Case No. 05-2188-cv-JPM-tmp

CONSENT ORDER

APPENDIX B.1
South Bluffs Apartments

APPENDIX C.1
Island Park Apartments
(Memphis, TN)
Exterior Accessible Route Plan
and Unit Plans

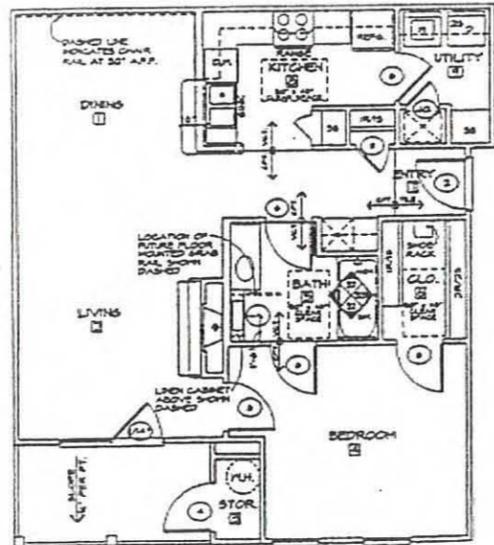
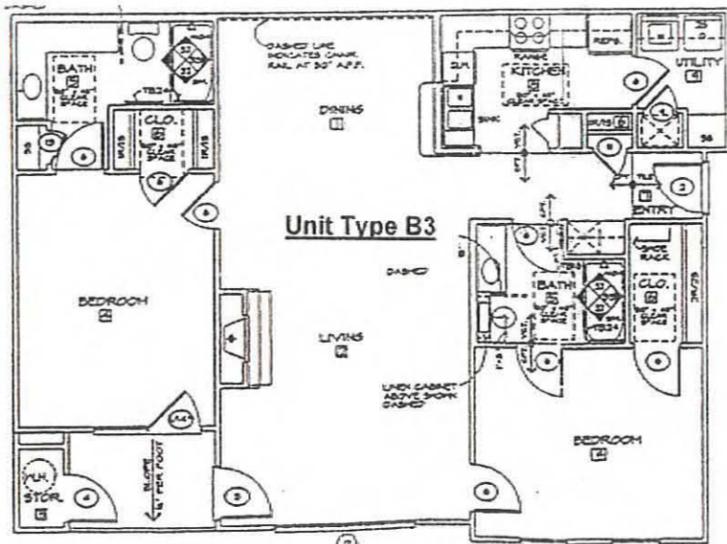
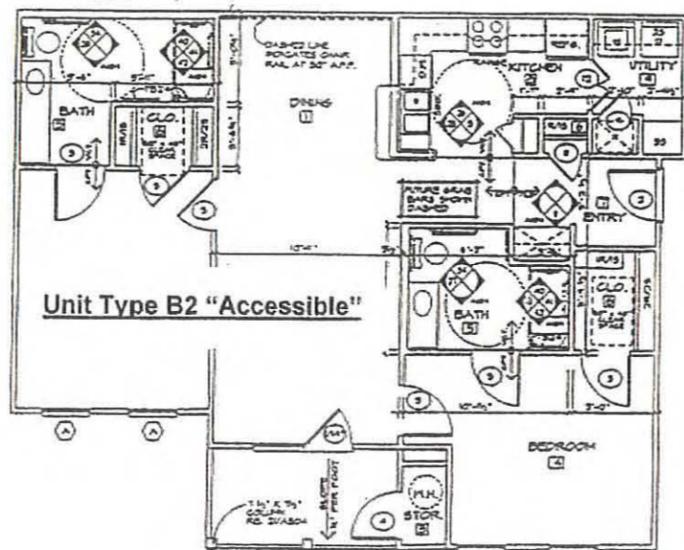
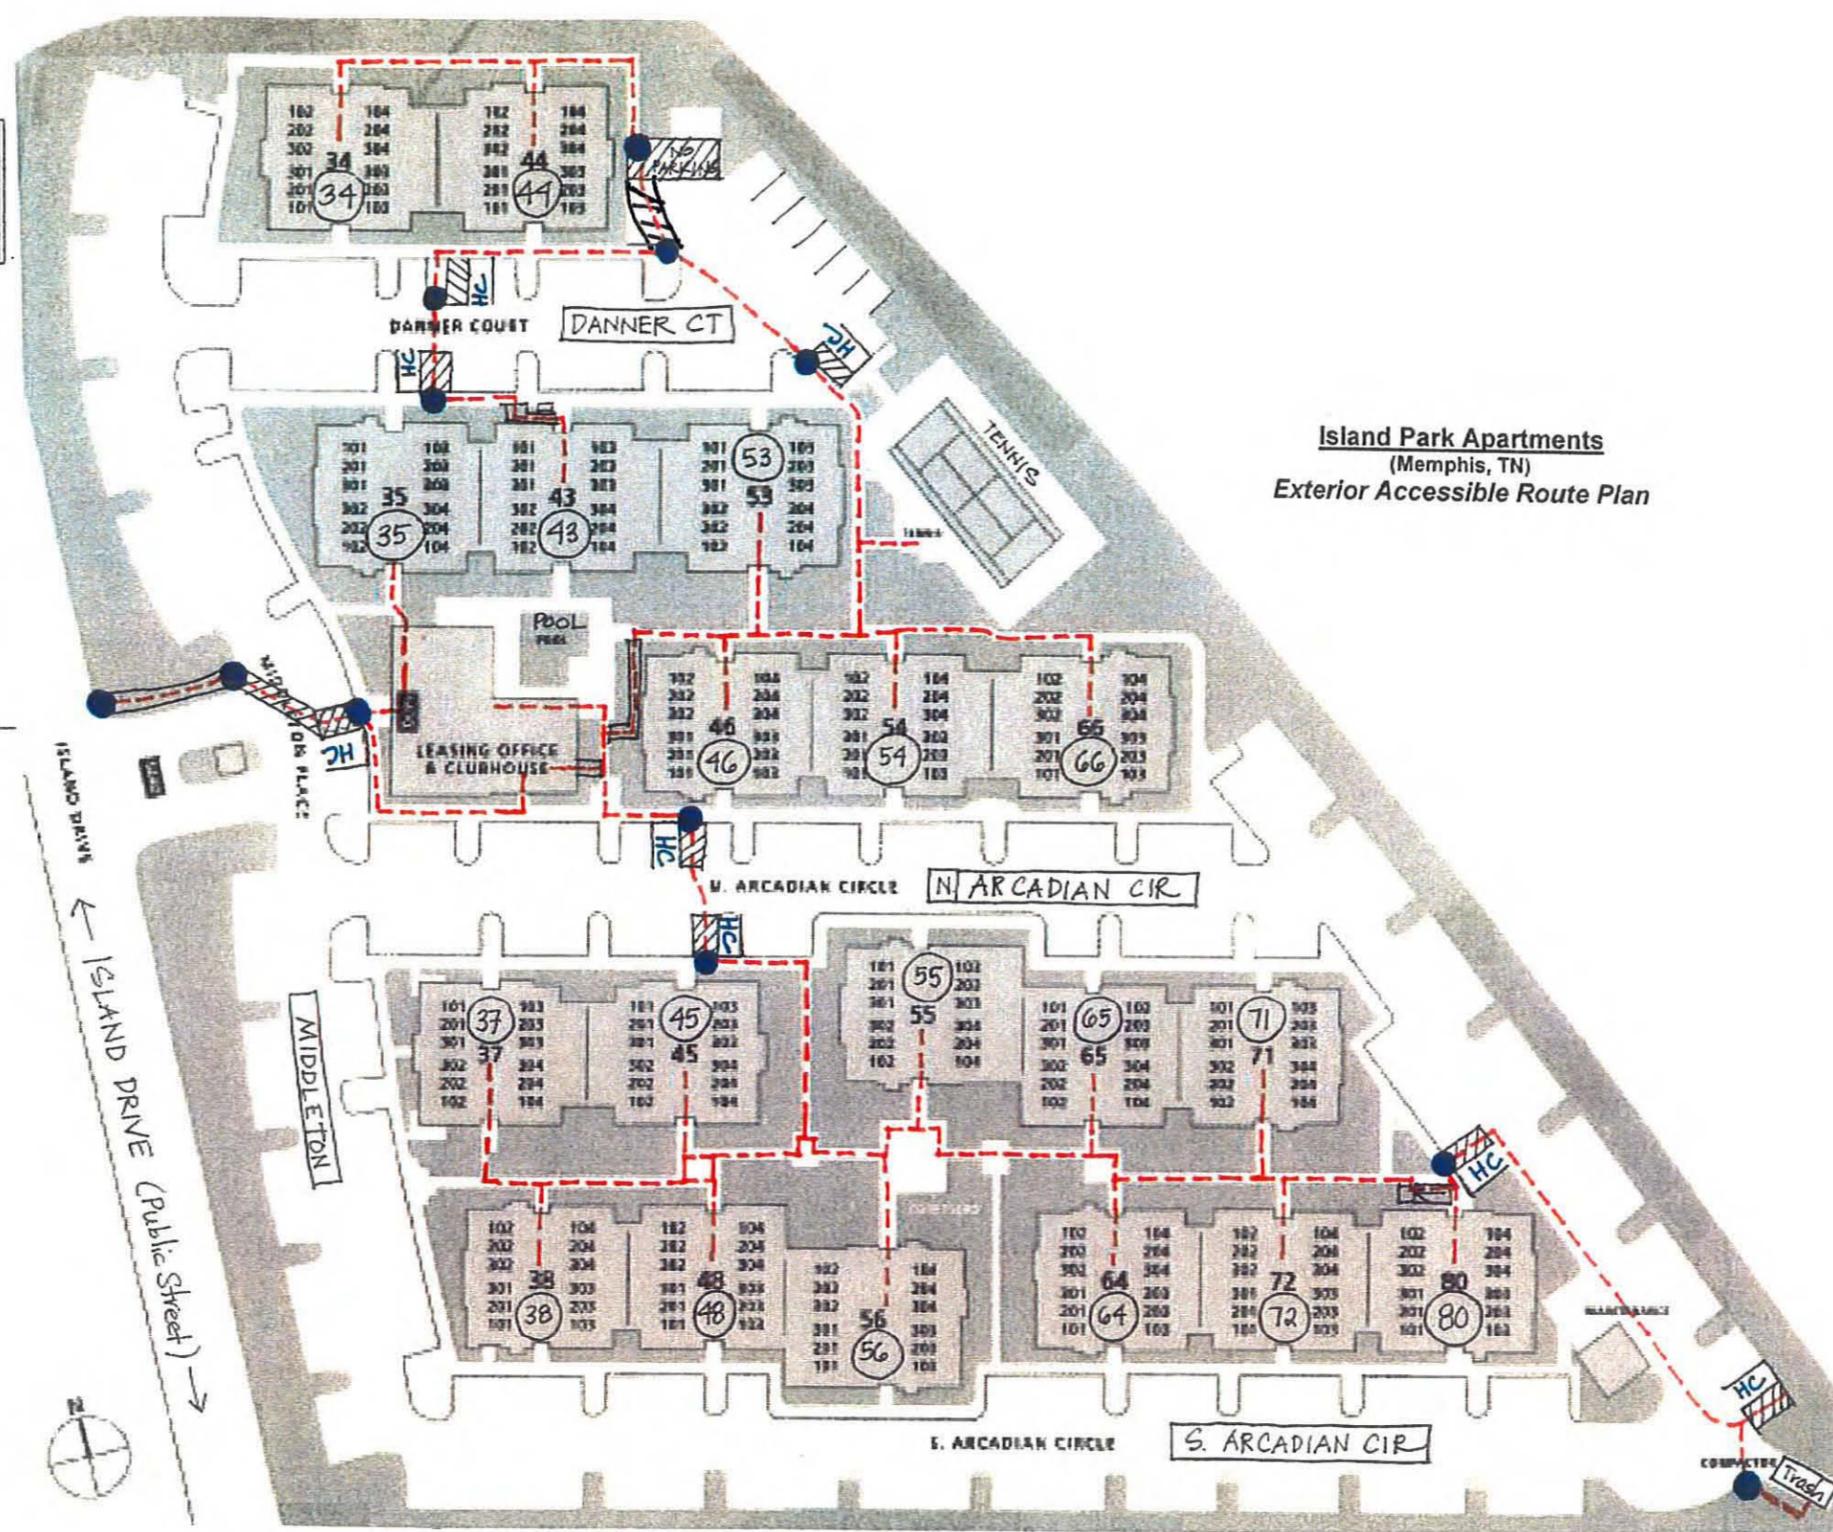
3	12, 14	D.	The accessible routes from the parking area to the building entrances have abrupt level changes, greater than 1/4", without bevel or ramp features at the following locations: 44 Danner Ct (6" step riser at south-side breezeway entry). 3857	Provide new accessible route at the breezeways at the north sides of Buildings 34 and 44. Add "No Parking" striping to ensure that curb ramp will not be blocked by illegally parked vehicles. Make compliant with ANSI 4.5.2, FHAG Requirements 1 & 2.	
4	15	3	35 Danner Court (2 step risers at front of north breezeway) 3872	Provide new accessible route on the south side of the Building 35 breezeway, near the existing resident gate. Also add new portion of walkway at the existing resident gate in order to provide an ANSI compliant minimum 18" pull side by minimum 60" long maneuvering space perpendicular to the face of the gate. Make compliant with ANSI 4.5.2, 4.13.6, FHAG Requirements 1 & 2.

5	17	5	45 N. Arcadian Circle (3/4" lip at south access walkway in courtyard). 3933, 3940	Remove 3/4" lip at the courtyard side entry to the breezeway at Building 45 to make compliant with ANSI 4.5.2.	
6	18-19	6-7	55 N. Arcadian Circle (2 step risers at front of north breezeway). 4042, 4277; 71 N. Arcadian Circle (2 step risers at front north breezeway). 4191, 4196	See Line 2, 3-10.	
7	20	8	37 N. Arcadian Circle (1/2" high plumbing clean-out in the center of the breezeway). 3926	Adjust the top of the cleanout valve to be flush with the existing walkway at the breezeway of Building 37 and to make compliant with ANSI 4.5.2.

Violation	Retrofit
8	20.1		Building 80 (1 step riser at the courtyard side breezeway)	Rework portion of the breezeway entry and provide a new maximum 8.33% ramp with level landings at the top and the bottom of the new ramp. Coordinate with the new curb ramp and the new accessible parking space at the northeast corner of Building 80. Make compliant with ANSI 4.5.2.
9	21, 25	E. 4	The routes from the parking space curb ramps to building entrances have cross slopes exceeding 2% in the following locations: 43 Danner Court – North approach walkway has at the center an 11.4% cross slope, to the left side a 3.4%, and at the right side a 3.9% cross slope. 3878, 3879, 3877, 3884	Rework area at the north breezeway entry to Building 43 as follows: Replace one concrete square at the breezeway entry, add a new ramp with level landings at the top and bottom, add a new walkway around the existing transformer box, and replace approximately 10' 0" of existing walkway along the north side of Building 35 in order to provide new walkway with cross slopes compliant with 4.3.7.

Violation	Retrofit
15	81-96	N.	<p>At ground floor apartments, the main entrance has a threshold (max allowed 1/2") which has an abrupt vertical level change greater than 1/4" without the required 1:2 ratio beveled slope at the following locations: 34 Danner Ct(#101-3/4";#102-3/4";#104-1/2").3849, 3851, 3942, 3943; 35 Danner Ct (#102-1/2"; #103-1").3874; 43 Danner Ct (#103-1"); 53 Danner Ct(#101-1"; #102- 1"; #103-1/2"; #104-1"); 46 N. Arcadian Cir(#101-3/4"; #102-1"; #103-3/4"; #104- 1 1/4"). 3896; 54 N. Arcadian Cir(#101- 1 1/4"; #102-1"; #103-1 1/4 "; #104-1 3/8"). 3904; 66 N. Arcadian Cir (#101-1 1/4"; #102-1"; #103-7/8"; #104-1 3/8").3913, 3914; 37 N. Arcadian Cir (#103-1/2"); 45 N. Arcadian Cir (#101-5/8"; #104-1/2"); 55 N. Arcadian Cir (#101-1/2"; #103-3/4"). 4186; 65 N. Arcadian Cir (#102-1 1/4"; #104-1"); 71 N. Arcadian Cir (#101-3/4"; #103-1"; #104-3/4"). 4194, 4193; 38 S. Arcadian Cir (#101-1"; #102-1/2"; #103- 1 1/4"; #104-1 5/8").4246, 4247; 64 S. Arcadian Cir (#102-1 1/2"); 72 S. Arcadian Cir (#101-1 1/4"; #103-1 1/2"). 4220</p>	<p>At all ground floor units with thresholds 1/2" high to 1 1/4" high, add a 1:2 bevel strip at the thresholds to make compliant with FHAG Requirement #2 and ANSI 4.13.8. At all ground floor units, for thresholds under 1/2" high and without sloped maneuvering space-no change. At all ground floor units with thresholds over 1-1/4" high, see retrofit at line 14, 66-80.</p>

<p>1</p>	<p>189-194</p>	<p>III.A.</p>	<p>The following Fair housing Act violations were present relative to the minimum 32" clear passage width at doors. The swinging doors at the following locations have a clear width of less than the required 32": 1 Bedroom, 1 Bath, Plan A-1 (34 Danner Court, #102 surveyed) Utility (laundry / pantry) room door width of 30". 3948; 1 Bedroom, 1 Bath, Plan A-1a (54 N. Arcadian Circle, #104 surveyed) Utility room door width of 30 1/2". 478 & 479; 1 Bedroom, 1 Bath, HC Plan A-1A (72 S. Arcadian Circle, #101 surveyed) Utility room door width of 30". 4124; 2 Bedroom, 2 Bath, Plan B-2 (44 Danner Court, #101 surveyed) Utility room door width of 30". 3978; 2 Bedroom, 2 Bath, HC Plan B-2 (43 Danner Court, #103 surveyed) Utility room door width of 30". 4019;</p>	<p>At all ground floor units, replace hinges at the interior utility/laundry room doors with new swing-clear hinges.</p>

<p>2</p>	<p>195</p>	<p>5</p>	<p>2 Bedroom, 2 Bath, Plan B-3 (56 S. Arcadian, #102 surveyed) Utility room door width of 30 1/2". Door from 2nd Bedroom into Hall Bathroom door width of 30 1/2", 2nd Bedroom Walk-in Closet door width of 30 1/2", 2nd Bedroom entry door width of 30 1/2", Master Bedroom Walk-in Closet door width of 30 1/2", Master Bedroom entry door width of 30 1/2", 2nd Master Bedroom entry door width of 30 1/2". 534, 548, 557, 559, 577, 580, 570.</p>	<p>At all B-3 ground floor units, replace hinges on all non-complaint interior doors with new swing-clear hinges, including 7 listed: Utility/laundry; 2nd bedroom to hall bath; 2nd bedroom closet; 2nd bedroom entry; master bedroom closet; master bedroom entry and 2nd master bedroom entry.</p>

<p>3</p>	<p>196-201, 197.1, 201.1</p>	<p>IV.A.</p>	<p>In the following units the main entrance has a threshold (maximum allowable is 3/4") which has a vertical level change greater than 3/4": 1 Bedroom, 1 Bath, Plan A-1 (34 Danner Ct, #102 surveyed) abrupt level change of 1 1/8" at interior, and 1 1/2" at exterior.3943; 1 Bedroom, 1 Bath, Plan A-1a (54 N. Arcadian Cir, #104 surveyed) abrupt level change of 1 1/2" at interior, and 1 1/8" at exterior.461 & 462; 1 Bedroom, 1 Bath, HC Plan A-1A (72 S. Arcadian Cir, #101 surveyed) abrupt level change of 1 1/4" at interior, and 1 1/4" at exterior.4117; 1 Bedroom, 1 Bath, Plan A-2 (55 N. Arcadian Cir, #102 surveyed) abrupt level change of 1 1/8" at interior, and 2" at exterior.4081; 2 Bedroom, 2 Bath, HC Plan B-2 (43 Danner Ct, #103 surveyed) abrupt level change of 1 1/4" at interior, and 1 3/8" at exterior. 4012; 2 Bedroom, 2 Bath, Plan B-2 (44 Danner Ct, #101 surveyed) abrupt level change of 1 1/4" at interior, and 2 1/4" at exterior.3972; 2 Bedroom, 2 Bath, Plan B-3 (56 S. Arcadian Cir, #102 surveyed) abrupt level change of 1" at interior.521.</p>	<p>At all ground floor units with threshold heights of 1/2" or more, install beveled 1:2 transition strip at the interior side to make compliant with FHAG Requirement #4(2).</p>

<p>4</p>	<p>202, 203.1- 207.1</p>	<p>B.</p>	<p>In the following units there are thresholds on the patio doors from the interior approach which are higher than ¾": 1 Bedroom, 1 Bath, Plan A-1a (54 N. Arcadian Cir, #104 surveyed) abrupt level change of 7/8" at the interior side of patio door.512; 1 Bedroom, 1 Bath, HC Plan A-1A (72 S. Arcadian Cir, #101 surveyed) abrupt level change of 1 ¼" at interior side of patio door.4130, 4131; 1 Bedroom, 1 Bath, Plan A-2 (55 N. Arcadian Cir, #102 surveyed) abrupt level change of 1" at the interior side of patio door. 4111, 4112; 2 Bedroom, 2 Bath, HC Plan B-2 (43 Danner Ct, #103 surveyed) abrupt level change of 1 ¼" at the interior side of patio door.4031, 4033; 2 Bedroom, 2 Bath, Plan B-2 (44 Danner Ct, #101 surveyed) abrupt level change of 1 ¼" at the interior side of patio door.3992, 3993; 2 Bedroom, 2 Bath, Plan B-3 (56 S. Arcadian Cir, #102 surveyed) abrupt level change of 7/8" at the interior side of patio door.564.</p>	<p>At all ground floor units, install 1:2 beveled transition strips at any interior side patio door threshold that measures 1/2" or higher to make compliant with FHAG Requirement #4(2).</p>

<p>5</p>	<p>203</p>	<p>1</p>	<p>1 Bedroom, 1 Bath, Plan A-1 (34 Danner Court, #102 surveyed) abrupt level change of 3" at the interior side of patio door. 3962, 3963, 3964</p>	<p>At 31 Danner Court, #102, and at any similarly constructed ground floor interior patio door situation, install a built-up ramp (pemko or similar) at the underside of the carpet and install any required additional 1:2 bevel to make compliant with FHAG Requirement #4(2).</p>
<p>6</p>	<p>217</p>	<p>V.A.</p>	<p>The thermostat controls in certain units were mounted above the maximum side reach of a wheelchair user (54" maximum per ANSI and 48" maximum per Fair Housing Accessibility Guidelines).</p>	<p>At all ground floor units, lower existing thermostats located higher than 54" to 48" maximum or less above the finished floor to make compliant with FHAG Requirement #5.</p>

APPENDIX D.1
Harbortown Square Apartments
(Memphis, TN)
Exterior Accessible Route Plan
and Unit Plans

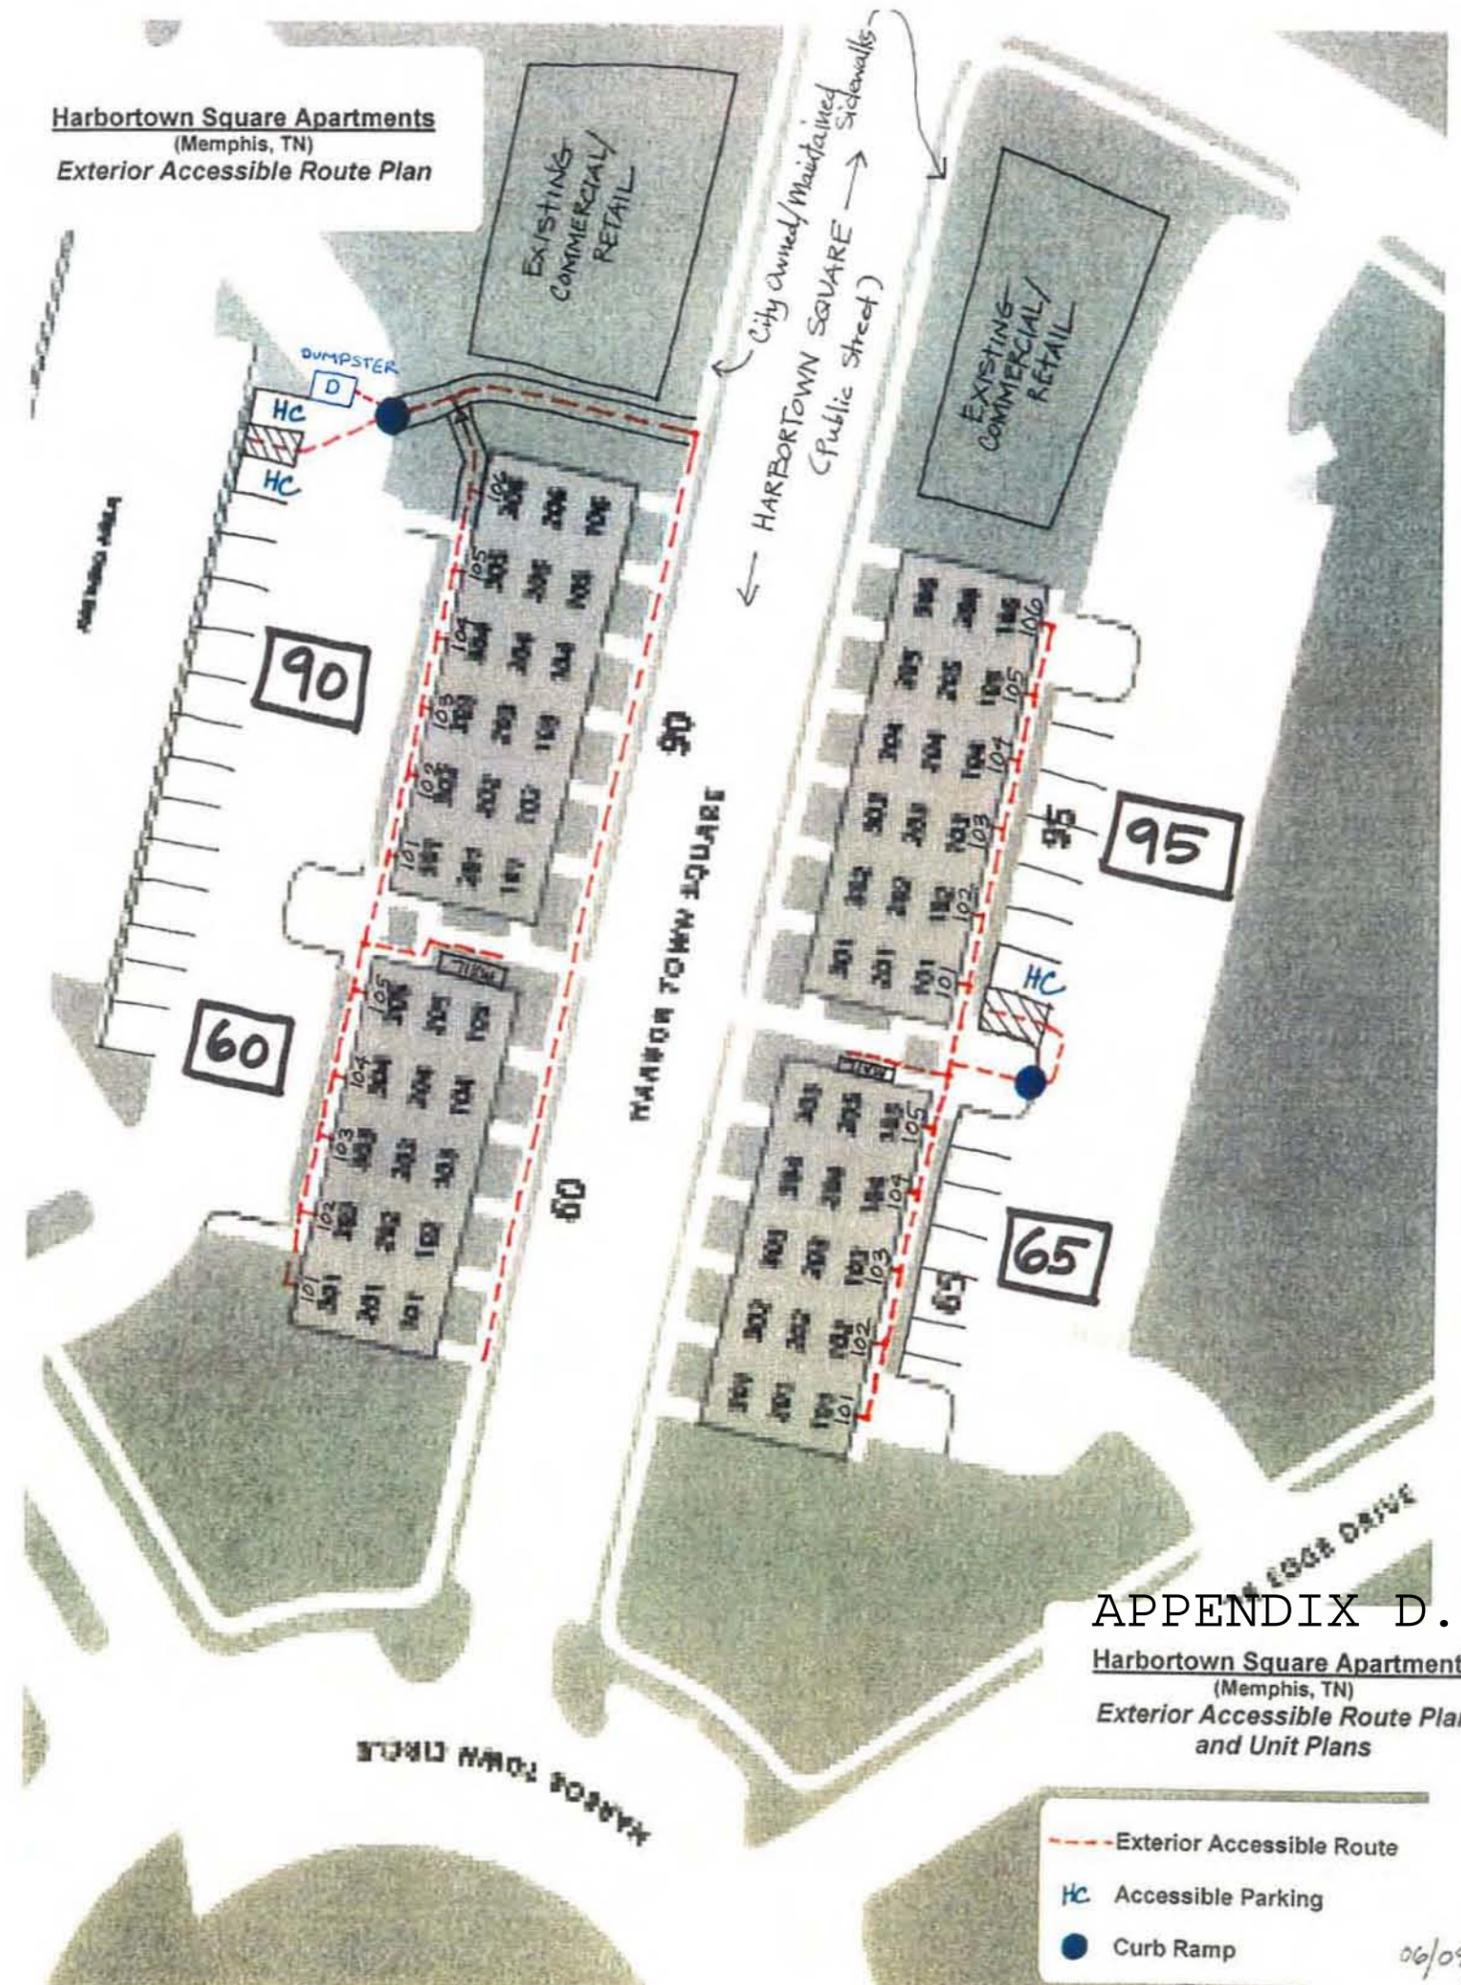
Violation	Retrofit
1	1	I.A.	There are no access aisles at the designated accessible parking spaces which serve the residential buildings, and the area where the access aisle (at 5.5%) would be slopes steeper than the maximum 5% running slope allowed along an accessible route which is not a ramp. 3677, 3702, 3649	At the north side of Building 90 provide two new accessible parking spaces with a shared 8' 0" wide access aisle (both spaces to be designated "van" per signage). Provide one new curb ramp with detectable warnings at end of the existing walkway between Building 90 and the commercial building. Also, provide a new approximately 16' long ramp with handrails on both sides/walkway at Building 90 near Unit #106 to connect to existing sidewalk on the northeast corner. Provide minimum 36" wide striping connecting the new access aisle and the new curb ramp. At the south side of Building 95, re-stripe a new minimum 5' 0" wide access aisle and a new 8' 0" accessible parking space (space to be directly connected to the existing curb ramp between Buildings 65 and 95). Relocate and raise existing accessible parking sign. Make compliant with ANSI 4.6.2 and 4.3.7.

2	10	5	At the top landing of the curb ramp situated between 65 and 95 Harbor Town Square there is a 4.8% cross slope that will create a barrier for those approaching the curb ramp. 3679	At the south side between Buildings 65 and 95, replace approximately 10'- 0" LF of walkway at the top of the curb ramp near the mailbox area. The new walkway is to have maximum 2.0% cross slopes. Make compliant with ANSI 4.3.7. Restripe, as necessary, access aisle and HC parking space parking just east of curb ramp between Buildings 65 and 95 to make ANSI complaint width for both.
3	11	6	At the bottom landing of the ramp in front of 95 Harbor Town Square Unit #101 there is a 4.0% cross slope. 3680	Replace and/or re-work approximately 6' 0" LF of walkway between the top of the curb ramp and the entry to Unit #101, Building 95. The new walkway is to have compliant slopes up to 8.33%, maximum 2.0% cross slopes, and a level landing in front of primary entry door to Unit 101. Coordinate with work in line 2,10, above. Make compliant with ANSI 4.3.7.
